# Access Compliance Report

## Public Rights-of-Way (Curb Ramps)

| Intersection ID: 21431 | Main Street: WOODSTREAM_DR | Cross Street: WRENTREE_DR | Location: NW           |
| ADA ID: 225F8B581916   | Ramp Type: Directional1    | Initial Pass/Fail: Fail   | Overall Compliance: No |

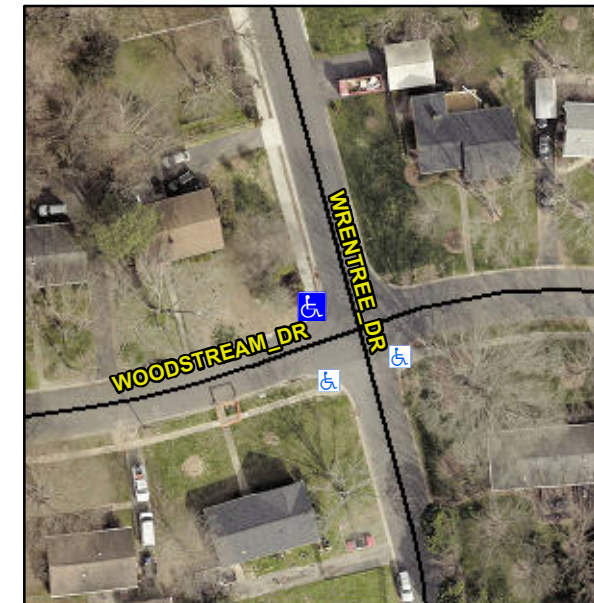
**R304.5.3**

| Compliance | Description           | Data  | Compliance | Description                 | Data |
|------------|-----------------------|-------|------------|-----------------------------|------|
| No         | Ramp XSlope (%)       | 5.2   |            |                             |      |

**Remove & Replace Entire Ramp.**
